# ***Proposed District Plan Change 73***

## **Suburban Centre Review – Centres**

(Annotated Chapters showing amendments approved by Council)

### **Wellington City District Plan**

Amendment to Planning Map 11

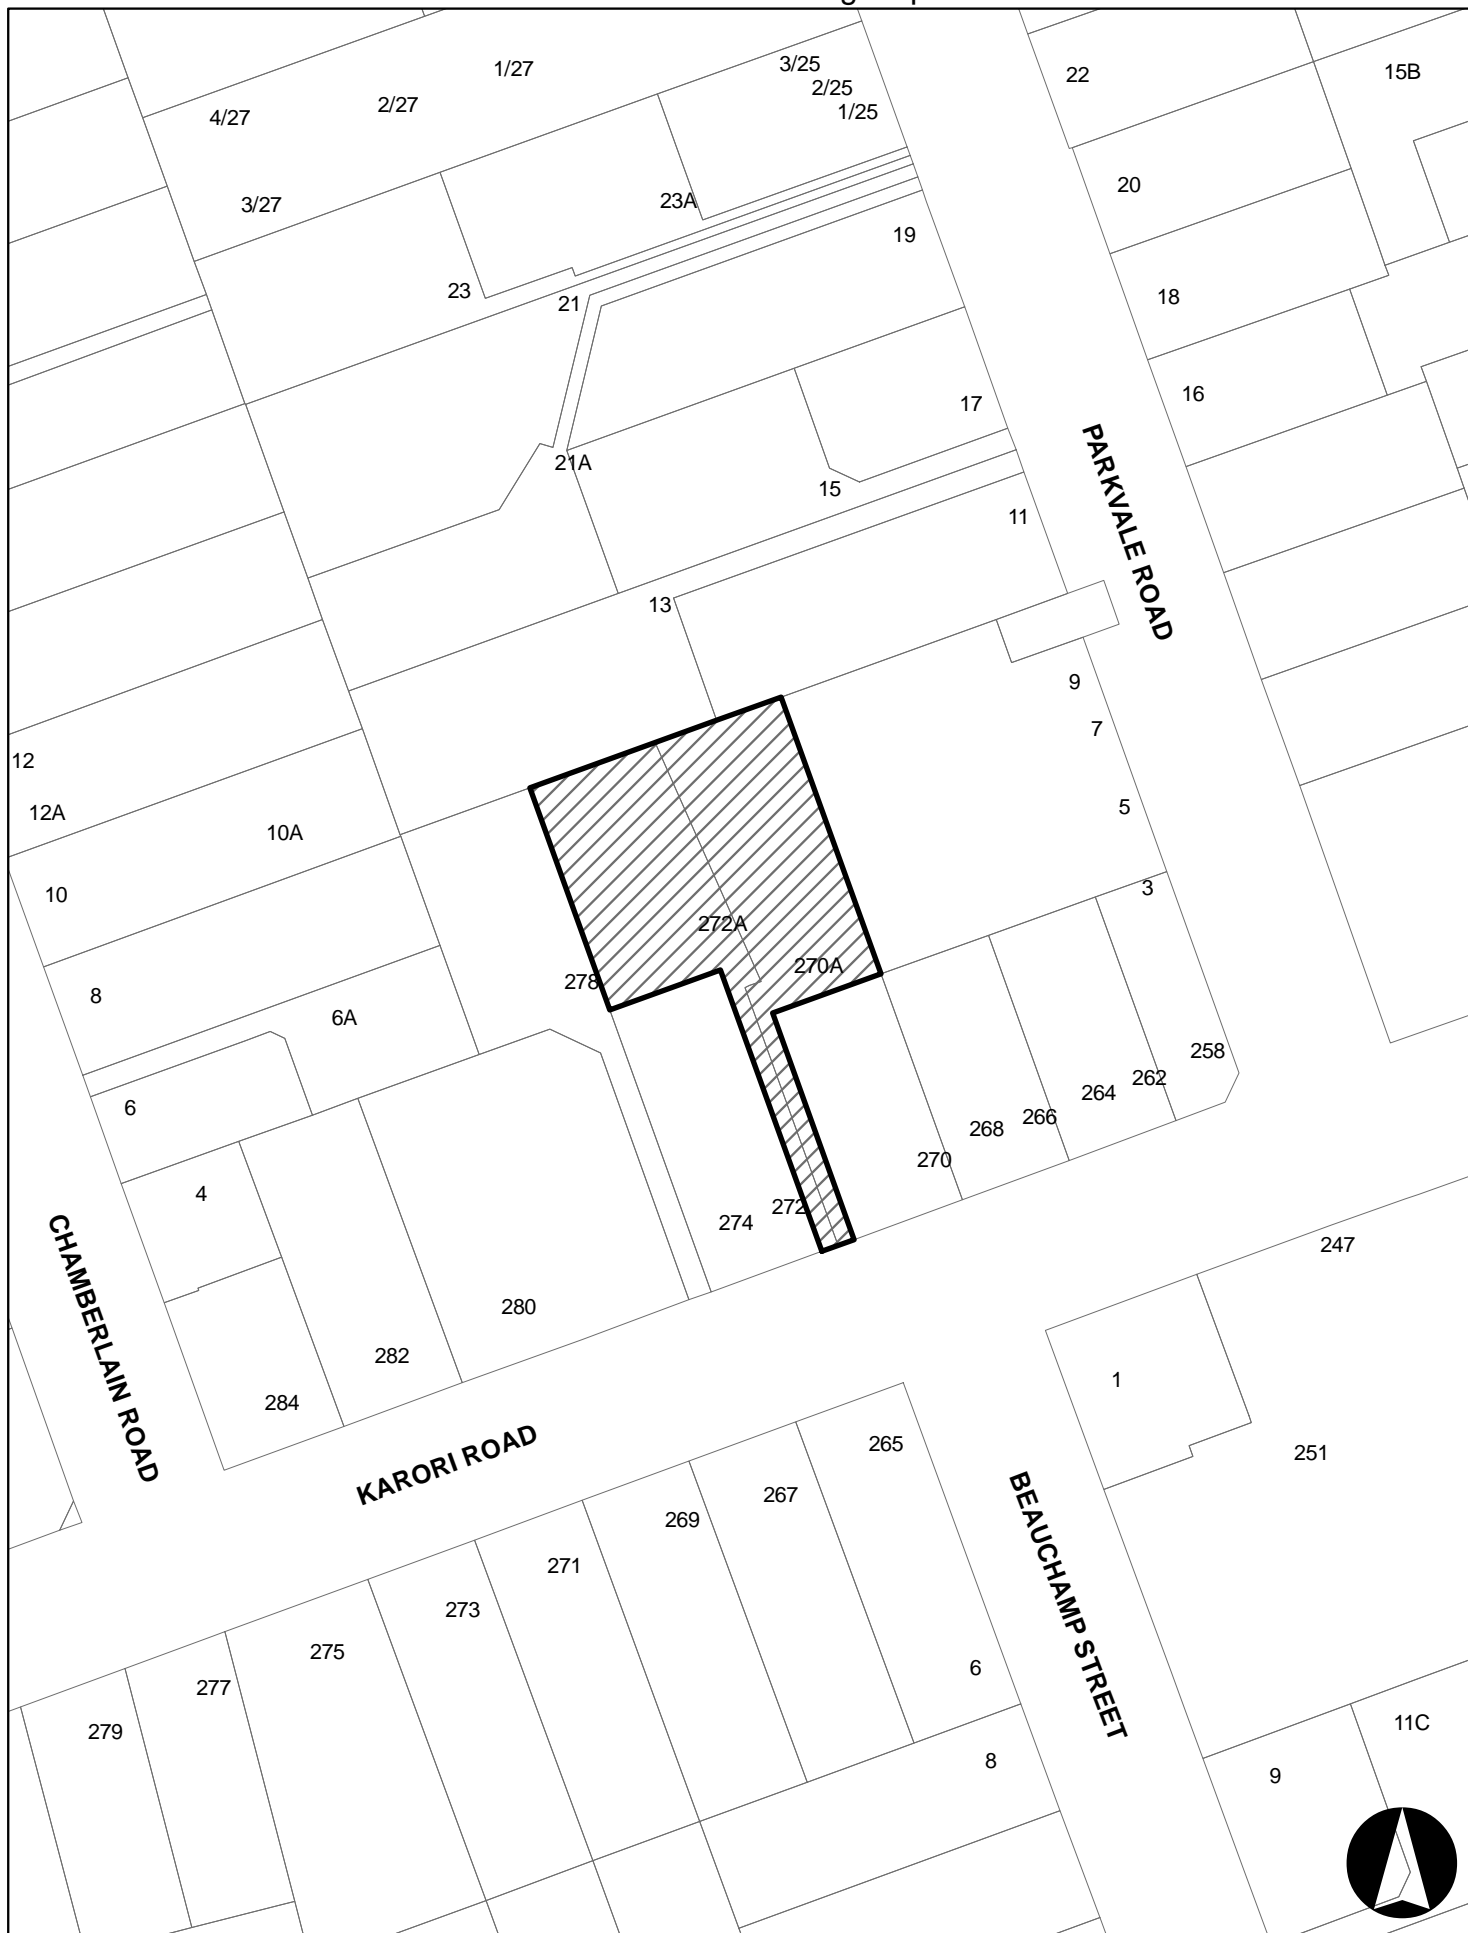
Decision on 270A, 272A and 272B Karori Road

Amendment to Planning Map 6

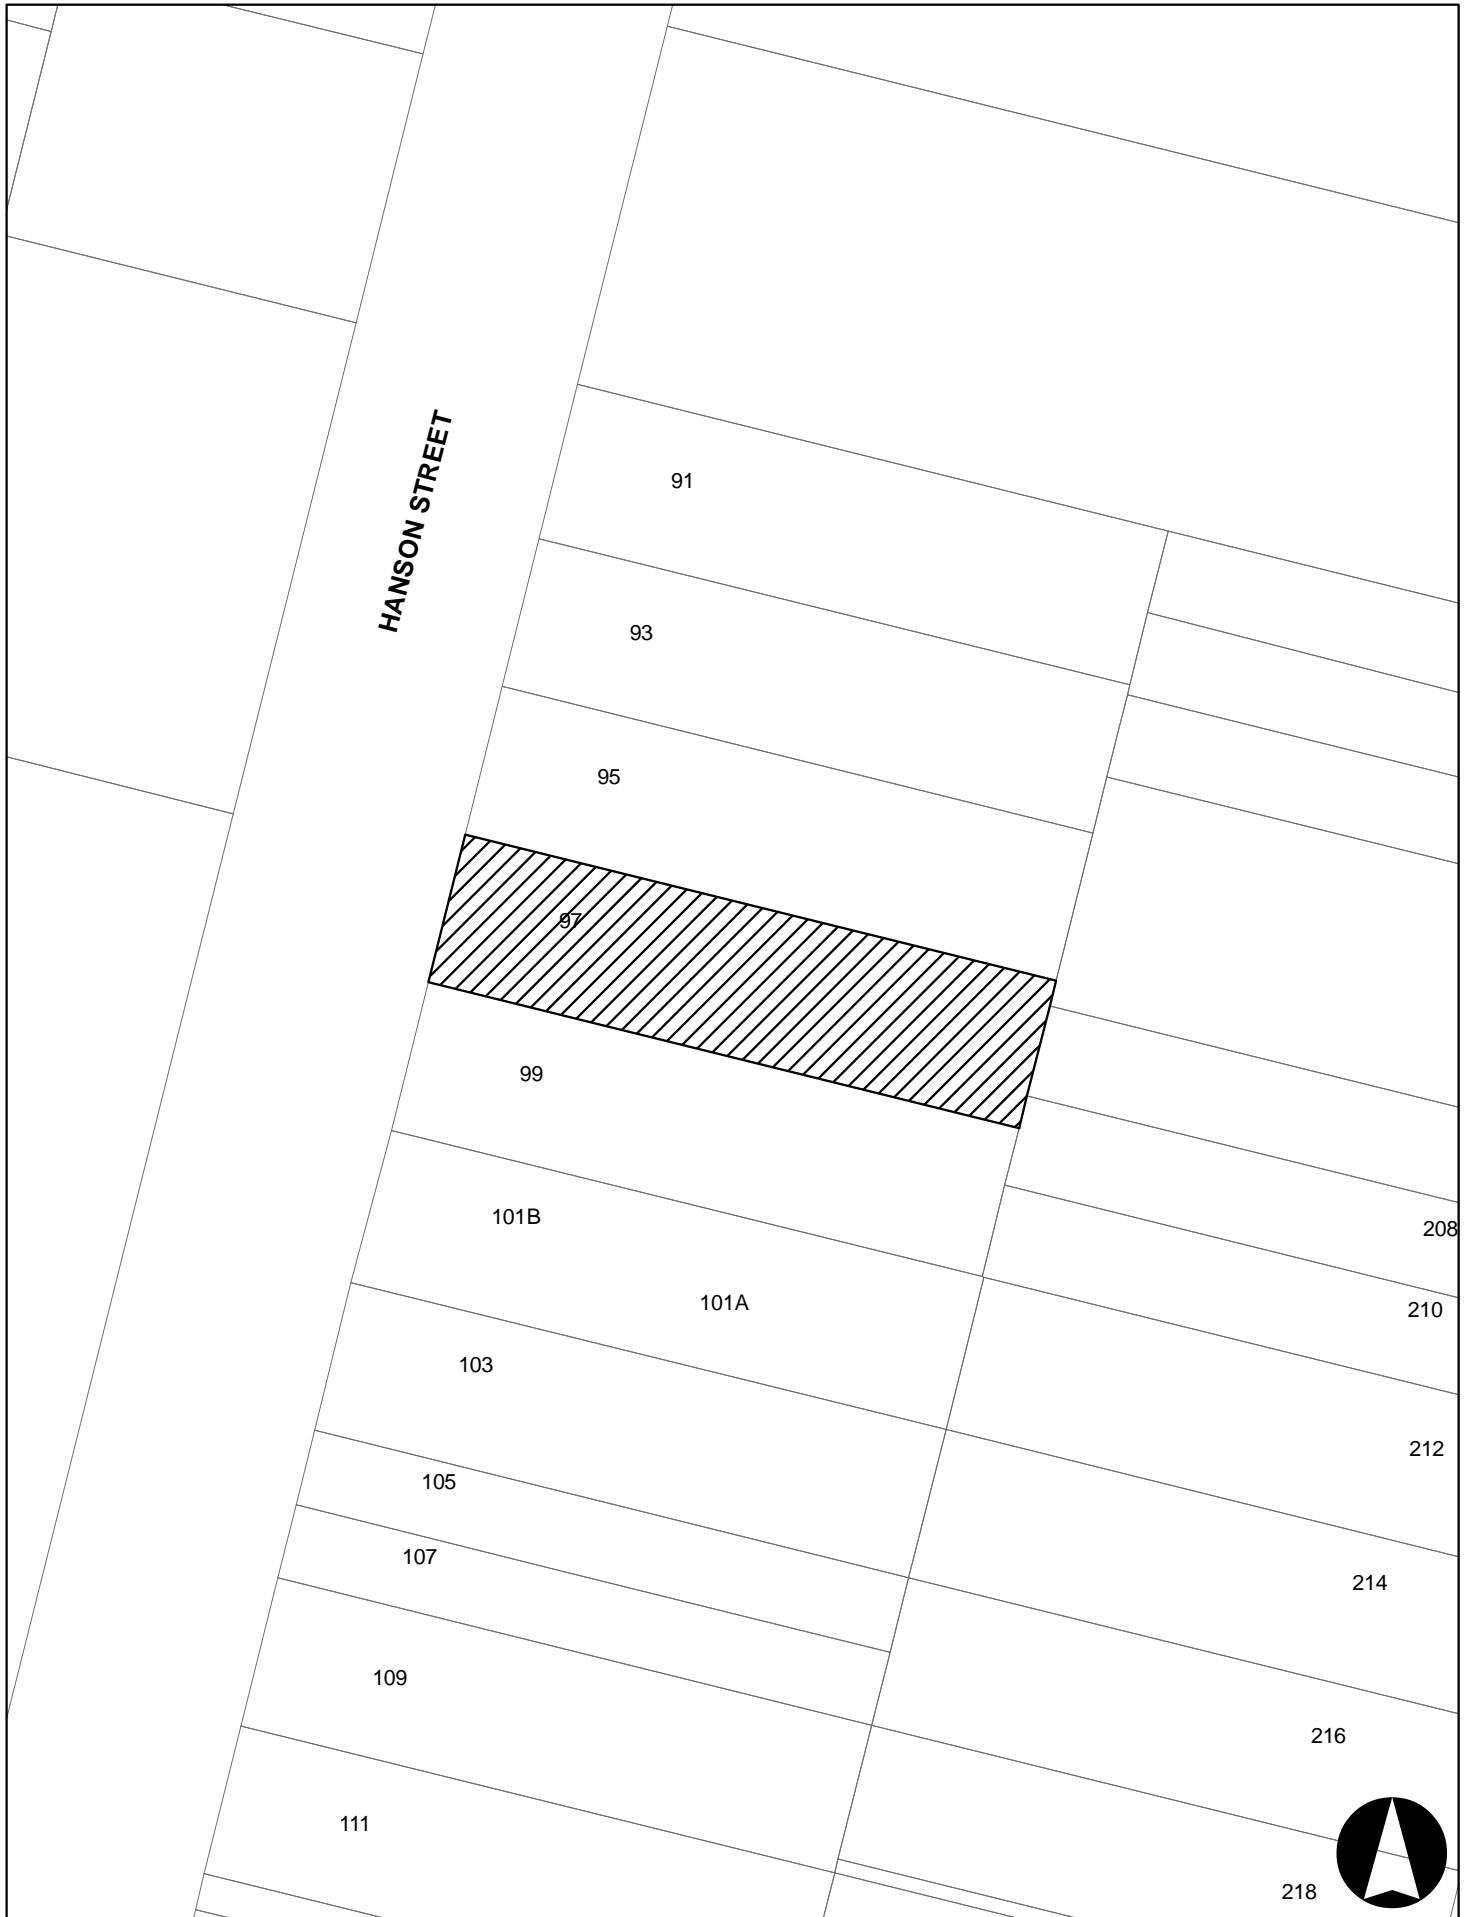
Decision on 97 Hanson Street, Newtown
